QUALITY IMPROVEMENT SHEET (Q.I.S.)

MODEL CODE YM/MODEL NAME	TITLE	QIS CONTROL #
CG6	KEY COMES OUT OF IGNITION SWITCH WHILE IN GEAR	MV20040426180508
02/ACCORD		
OCCURRENCE DESCRIPTION		
Key comes out of the Ignition Switch while the transmission is in gear

Quality Committee (JQC)

Key comes out in ranges other than P

2002MY→2003MY Accord Change points

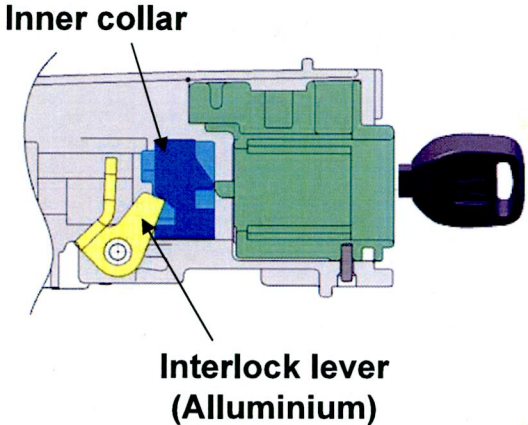
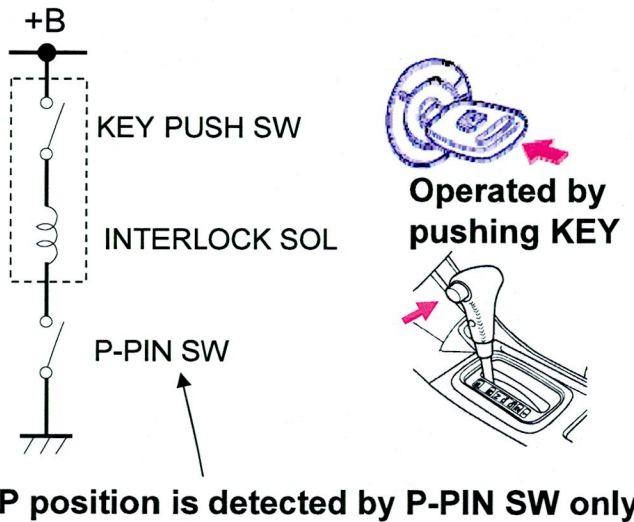
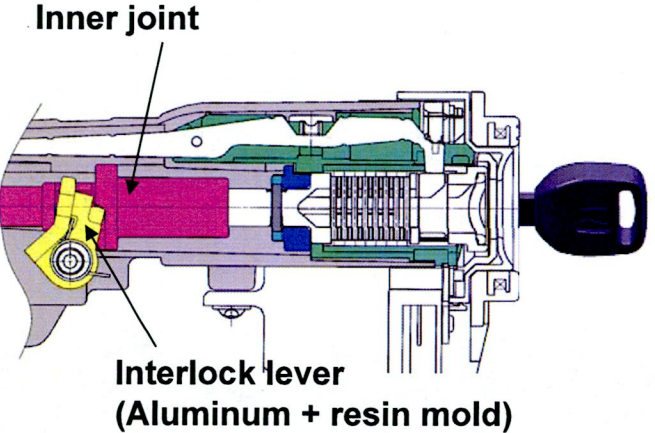
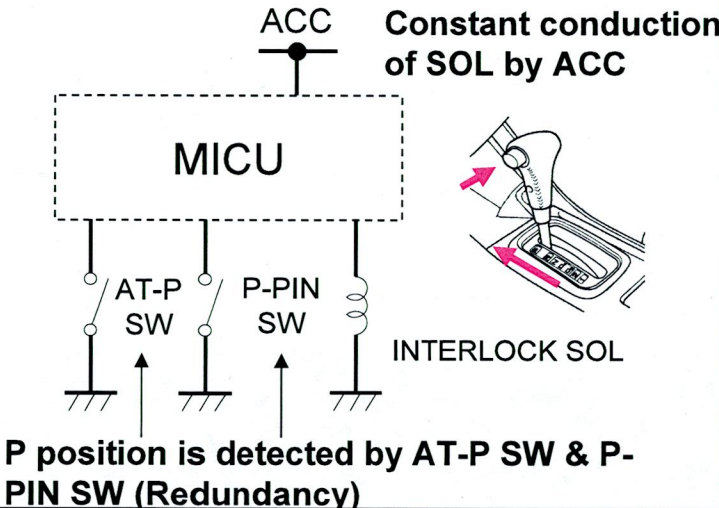
Improvement of performance/ Weight reduction (Body: ZnDc→Mg)
(Unification change of overall steering lock)

1.Explanation of SPEC change of lever shaft press fit height

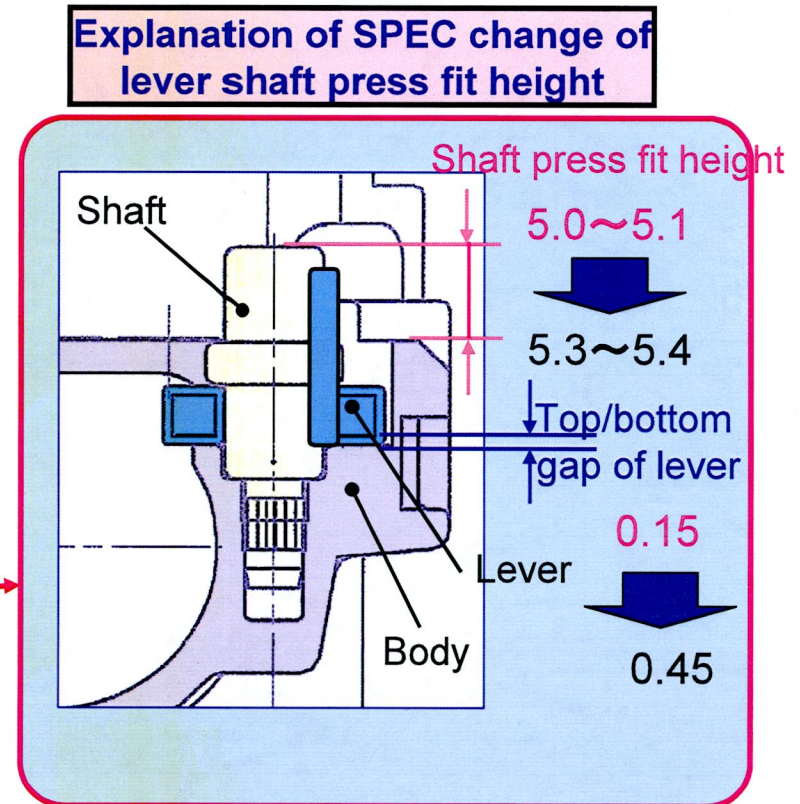
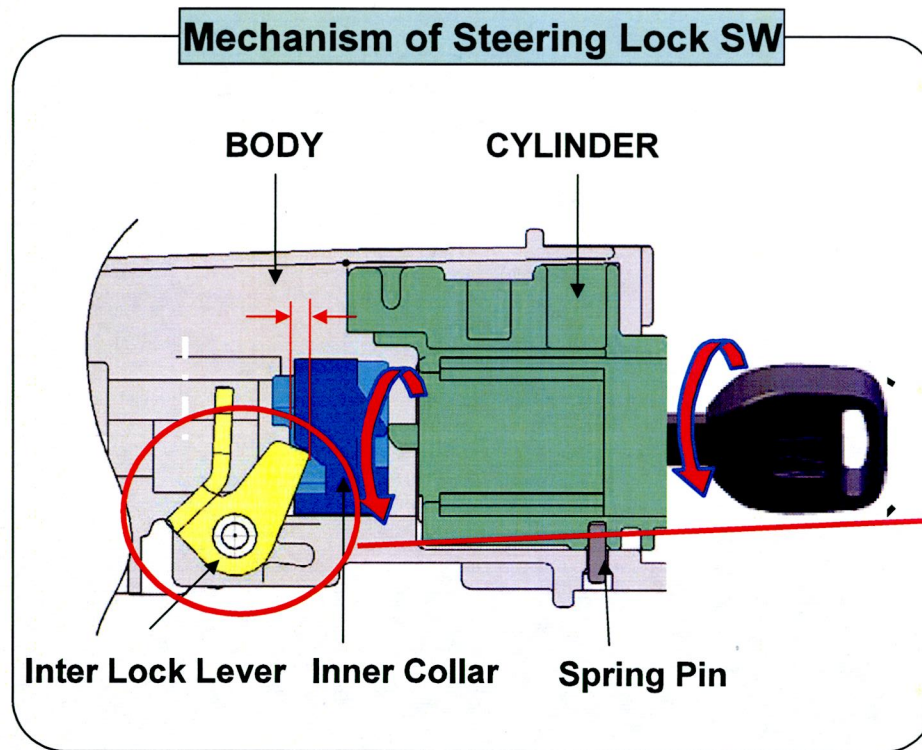
- ◆ Purpose : By revising top/bottom gap of lever and shaft to an adequate setting, aim stabilization of lever rotation function (response) (Gap STD 0.15→0.45mm)
- ◆ Alteration content: Change SPEC value of shaft press fit height from 5.0~5.1mm → 5.3~5.4mm
- ◆ Application date: 27 JAN 2003
